Wollongong Local Planning Panel Assessment Report | 8 February 2022

WLPP No.	Item No. 1
DA No.	DA-2021/1135
Proposal	Construction of a ten (10) room boarding house
Property	Lot 52 DP 32220 46 Blackman Parade, UNANDERRA NSW 2526
Applicant	PDC Lawyers & Town Planners
Responsible Team	Development Assessment and Certification - City Wide Team (BM)

ASSESSMENT REPORT AND RECOMMENDATION

SITE PLAN / SITE ANALYSIS
PLAN

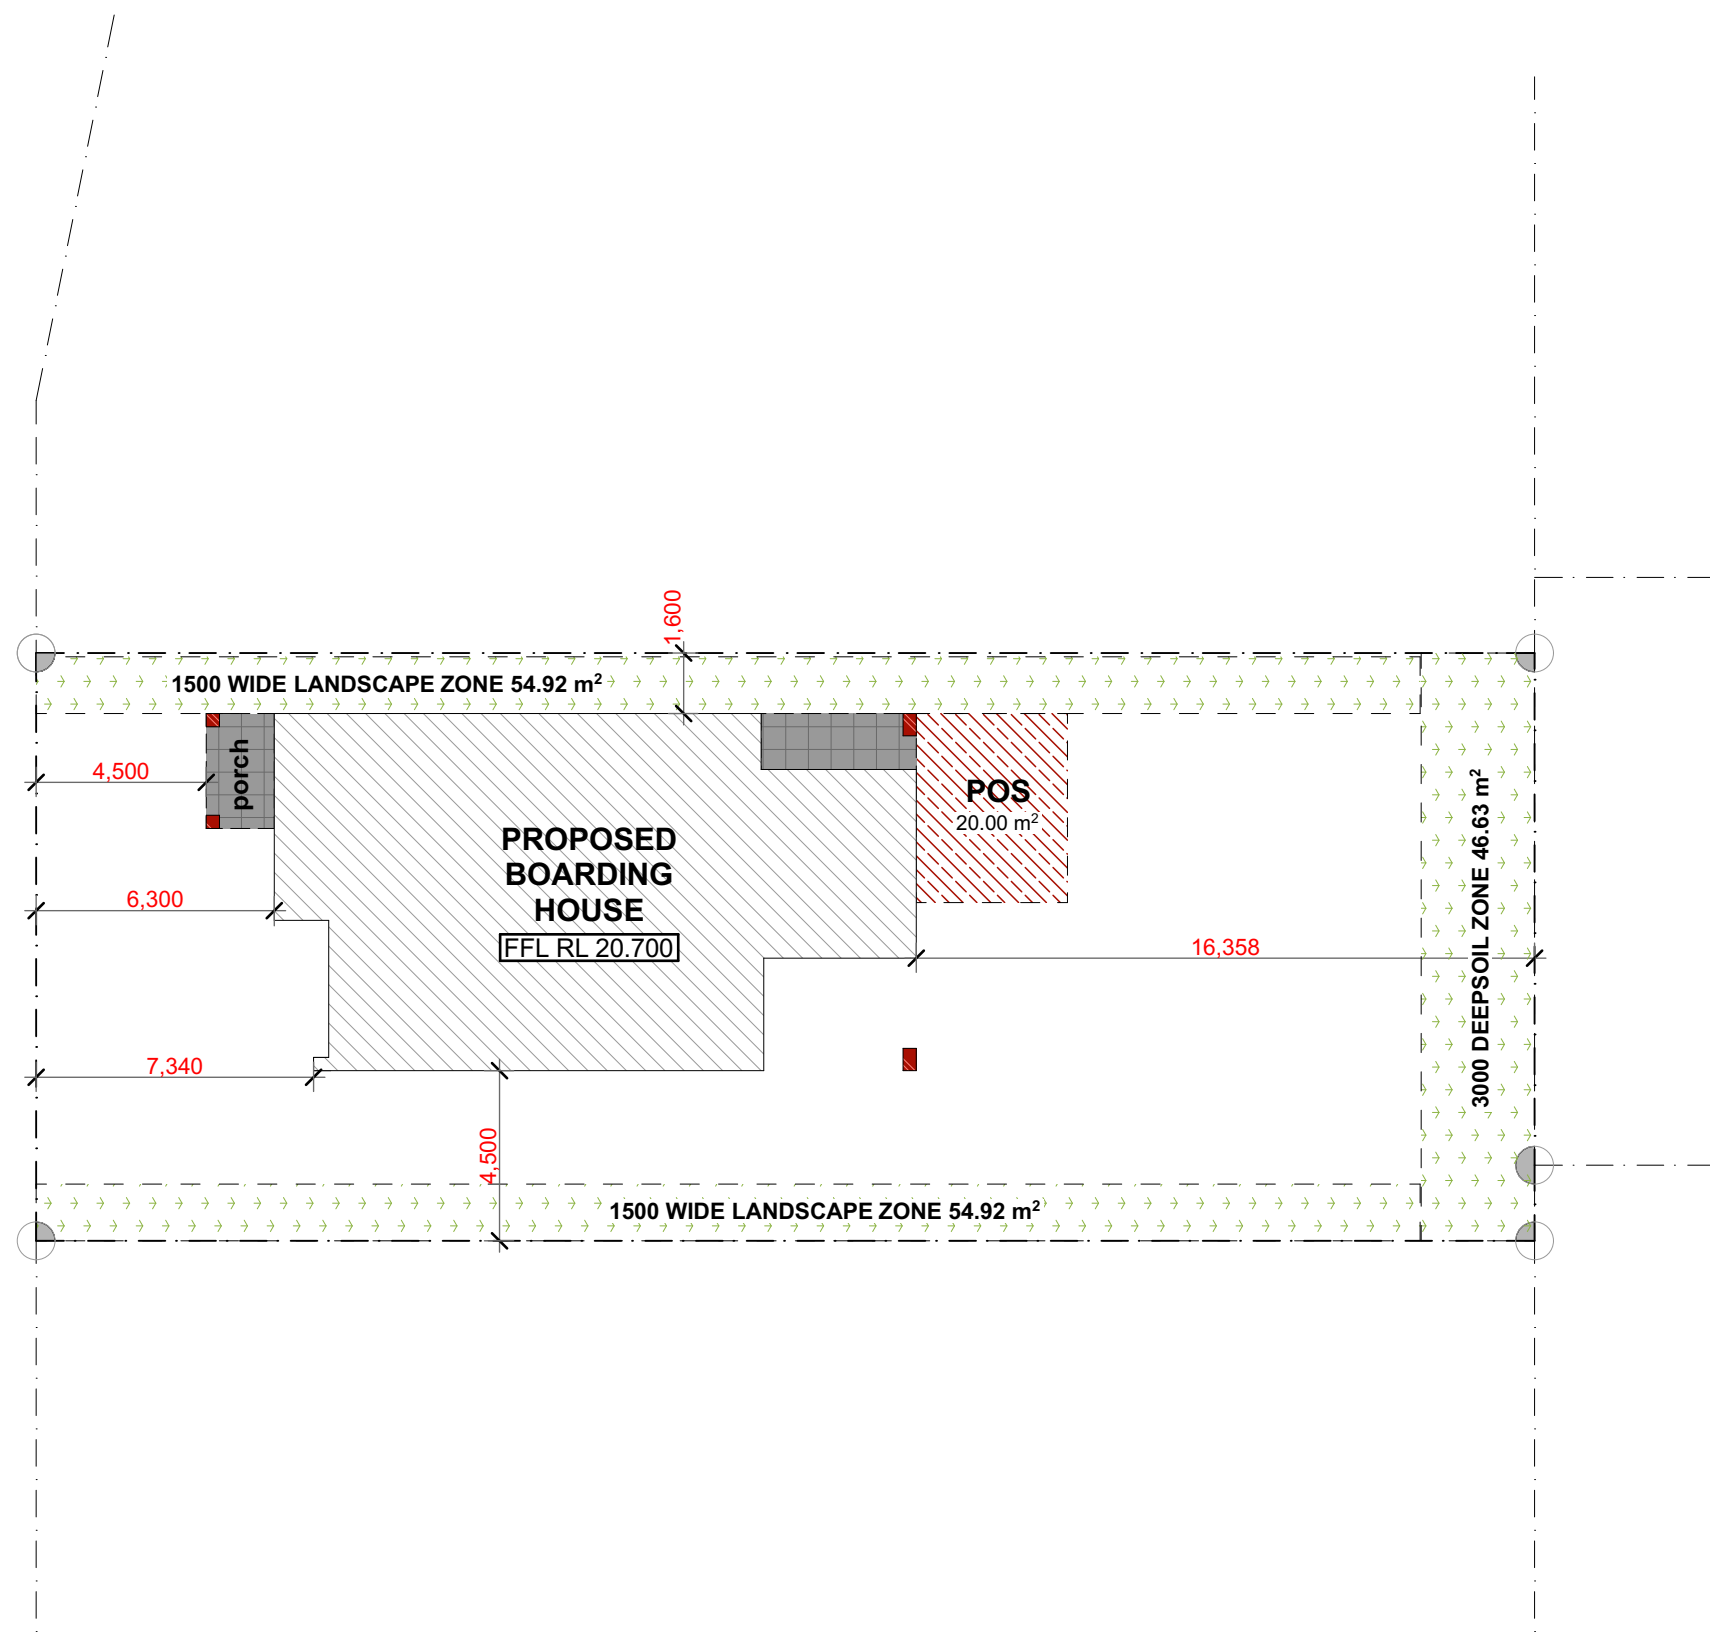
In accordance with Section iia), e) parking, 29, SEPP Affordable Rental Housing it is required to provide 5 car parking spaces for the proposed development. Only 3 spaces are provided as shown on the plans.

Boarding houses shall provide suitable disabled access arrangements.		Due to limited on street parking capability in this location it is considered the provisions of SEPP(ARH)2009 for 5 spaces should prevail over DCP parking controls

GROUND FLOOR PLAN		ISSUE
Drawing Number		A07
Project No:	2020-001	Drawn By: BT
		Checked By: BT
Date:	06/08/2021	Status: DA
		Scale: as noted

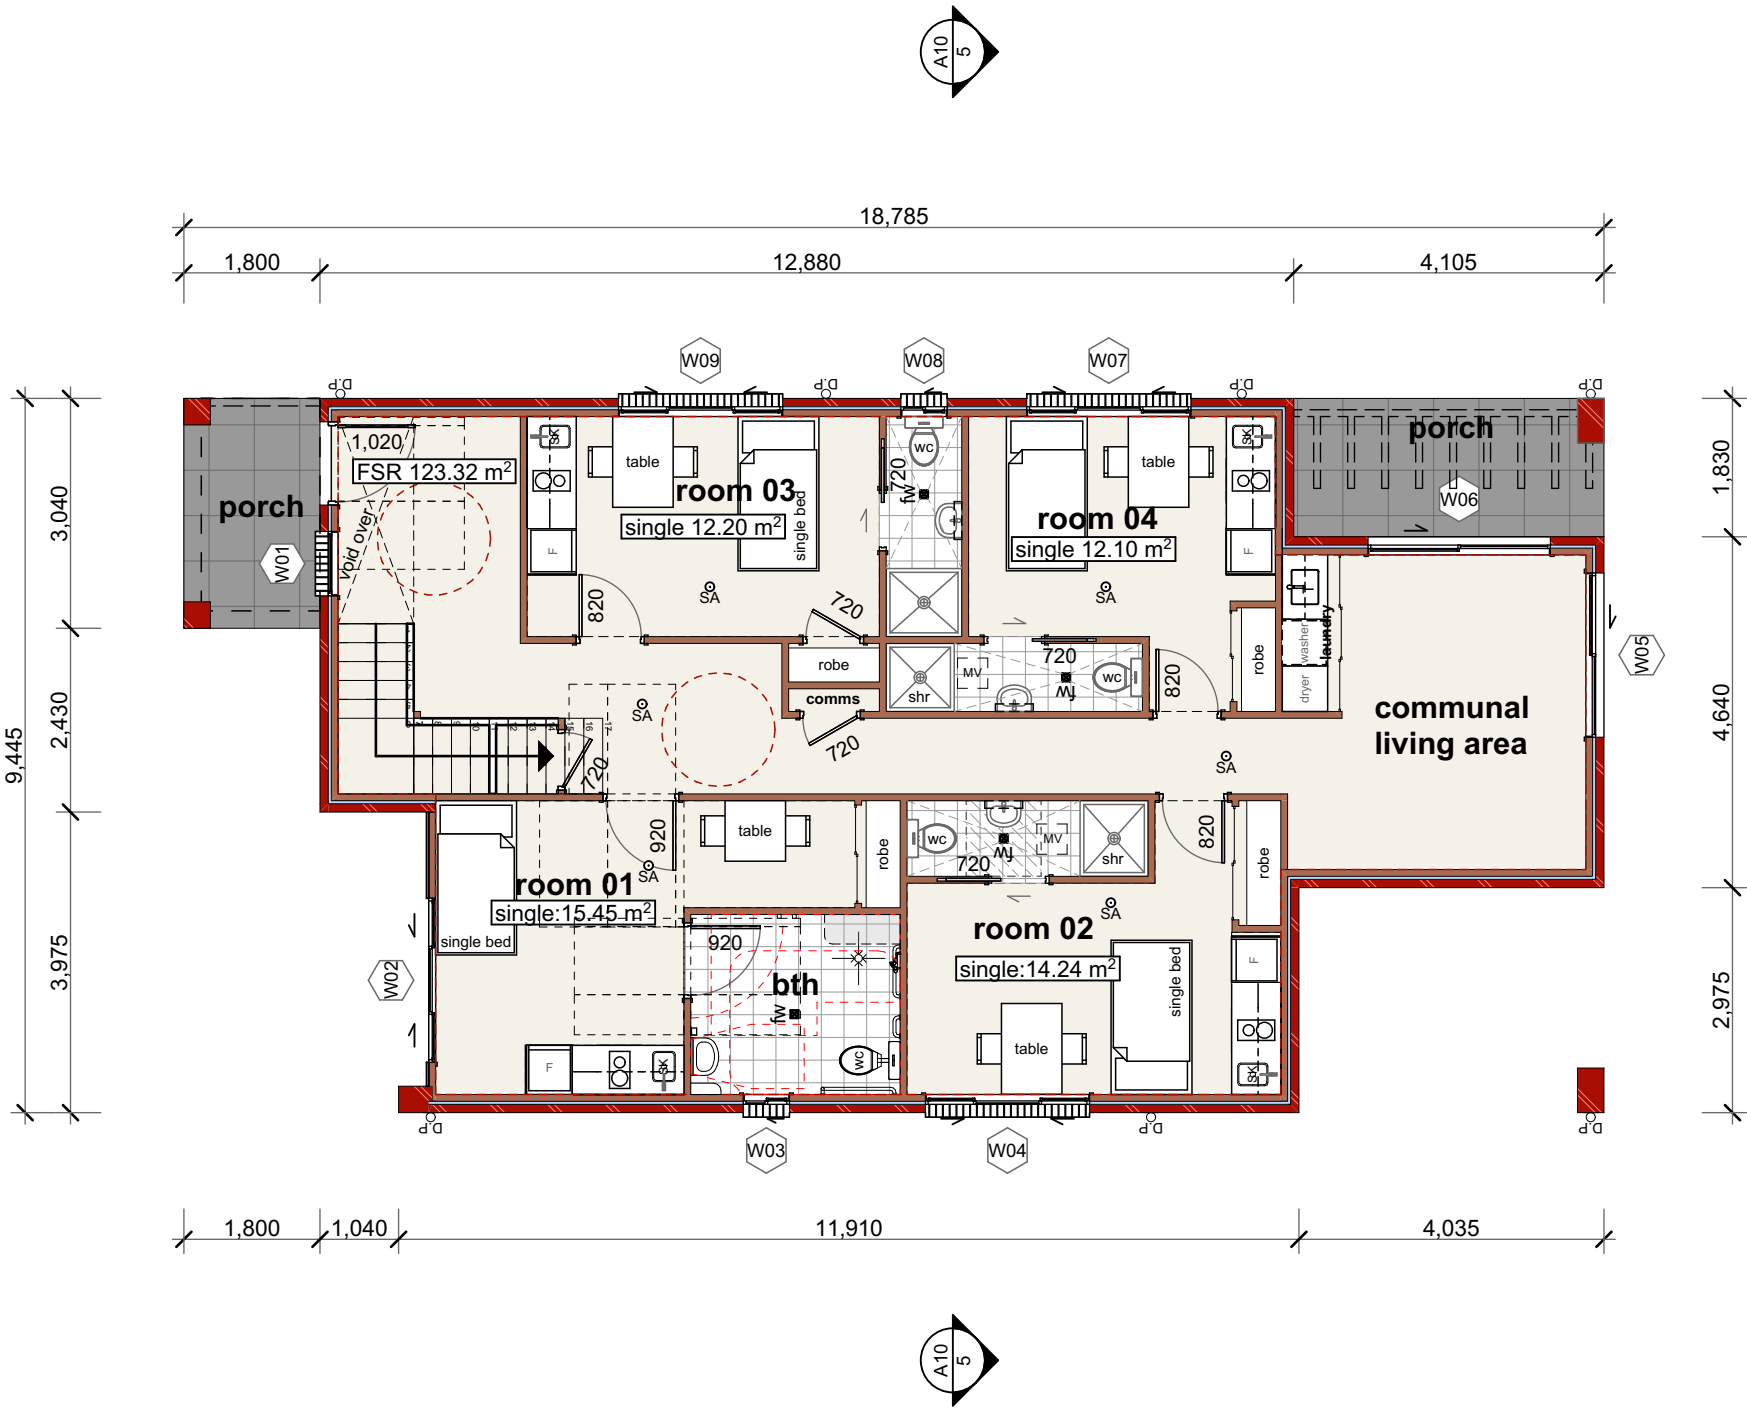
Comment: One (1) communal living room has been provided for the boarding house.

Comment: Submitted plans indicate that each boarding room is a single room only.

T# TREE TO BE REMOVED
SEE ARBORIST REPORT

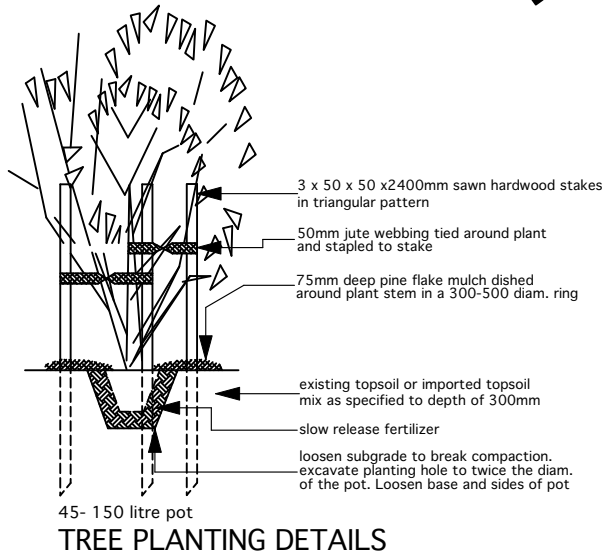
Council's Landscape Officer has raised concerns regarding the impact on trees. An arborist report was requested as additional information but has not been received in order to undertake a complete assessment.

Though no tree removal is proposed as part of the application the submitted landscape plan shows trees to be removed. The application submission was referred to Council's Landscape Officer for comment. A complete assessment couldn't be undertaken due the lack of submission of an arborist report.
